**ERRATA for**  
**PE Civil Structural Practice Exam**  
ISBN 978-1-932613-72-8  
Copyright 2014 (July 2016 Second Printing)  
Errata posted 8-16-2017

Revisions are shown in red.

Question 521, p. 47:

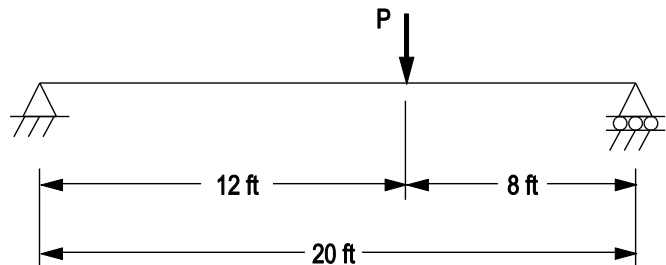
Question 521 should read as follows:

**521.** The W10 × 22 steel beam ( $F_y = 50$  ksi) shown in the figure is only braced at the center of span.

Work either the ASD or the LRFD version of the question, **considering the most conservative instance.**

The allowable **flexural strength** (ft-kips) of the beam is most nearly:

The **design** moment capacity  $\phi M_n$  (ft-kips) of the beam is most nearly:

**521.** The properties of a W10 × 22 are as follows:

$$\text{ASD: } M_{px}/\Omega_b - BF(L_b - L_p) = M_n/\Omega_b$$
$$64.9 - 2.68(10 - 4.7) = 50.7 \text{ ft-kips}$$

$$\text{LRFD: } \phi_b M_{px} - BF(L_b - L_p) = \phi_b M_n$$
$$97.5 - 4.02(10 - 4.7) = 76.2 \text{ ft-kips}$$

**THE CORRECT ANSWER IS: (B)**

Question 509, p. 38:

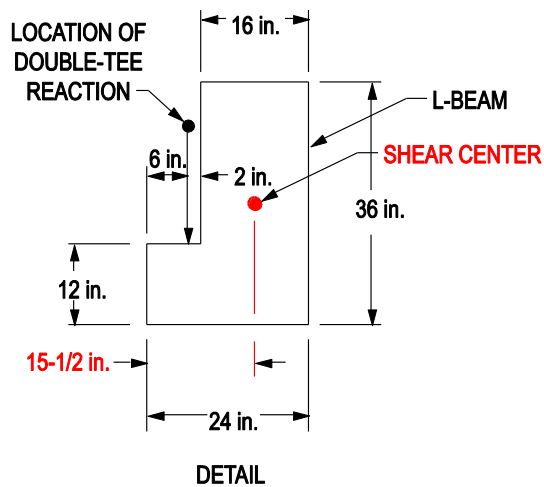
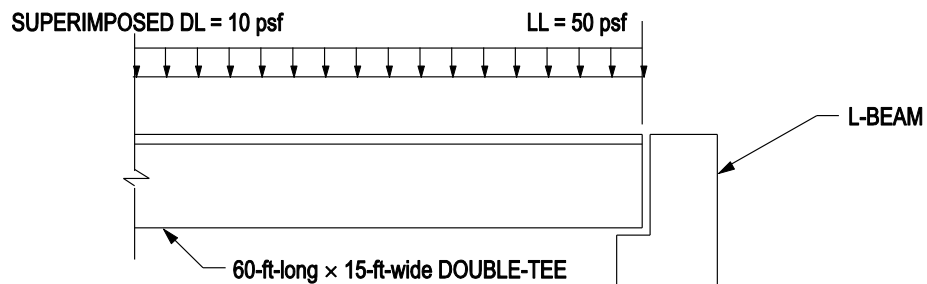
Question 509 should read as follows:

A double-tee supported by an L-beam is loaded as shown in the figure.

The magnitude of the ultimate torsion (ft-kips) induced into the L-beam, by superimposed dead and live load applied on the double-tee, is most nearly:

**Question 513, p. 41:**

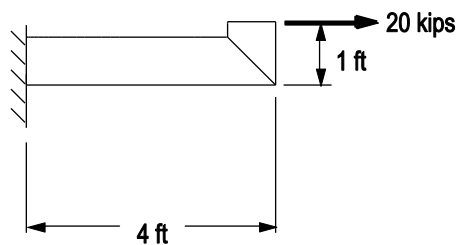
Question 513 should read as follows:

The pipe member shown in the figure has a constant section and the following properties:

Outside diameter	10 in.
Moment of inertia	90 in <sup>4</sup>
Area	7 in <sup>2</sup>

Neglecting the weight of the pipe, the maximum compressive stress (ksi) at the support is most nearly:

$$M_S = (20 \text{ kips})(12 \text{ in.} - 5 \text{ in.}) = 140 \text{ in.-kips}$$

$$\sigma_{\text{flexure}} = \frac{(140 \text{ in.-kips})(5 \text{ in.})}{90 \text{ in}^4} = 7.8 \text{ ksi} \begin{cases} \text{Top tension} \\ \text{Bottom compression} \end{cases}$$

$$\sigma_{\text{axial}} = \frac{20 \text{ kips}}{7 \text{ in}^2} = 2.9 \text{ ksi tension}$$

$$-7.8 \text{ ksi} + 2.9 \text{ ksi} = -4.9 \text{ ksi}$$

**THE CORRECT ANSWER IS: (B)**

**Question 528, p. 52:**

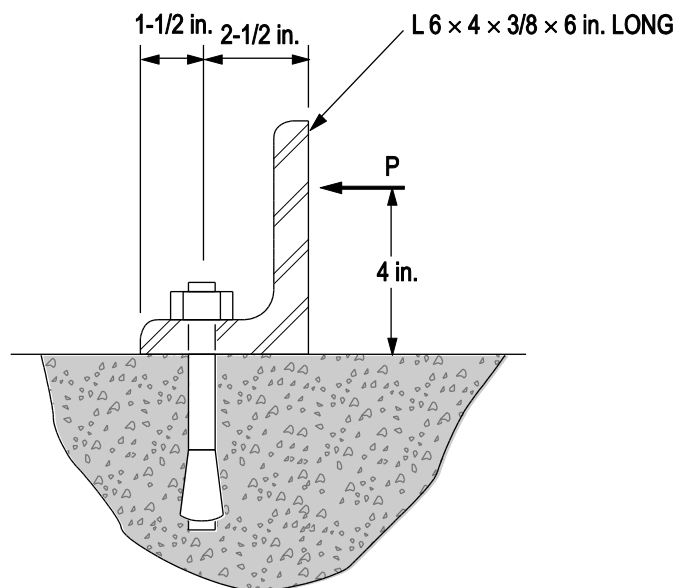
Question 528 should read as follows:

A connection is shown in the figure.

The load  $P$  is equally distributed along the entire 6-in.-long angle.

The maximum load  $P$  (ASD) or  $\phi P_n$  (LRFD) in kips that can be carried by the angle is most nearly:

By inspection P controls.

$$M_p = F_y Z_x = (36)(0.211) = 7.6 \text{ in.-kips} \quad \leftarrow \text{ governs}$$

$$P_{\text{allow}} = \frac{4.55}{\left[4 - (1/2)(3/8)\right]} = 1.19 \sim 1.2$$

$$\phi P_n = \frac{6.84}{\left[4 - (1/2)(3/8)\right]} = 1.79 \sim 1.8$$

**THE CORRECT ANSWER IS: (C)**
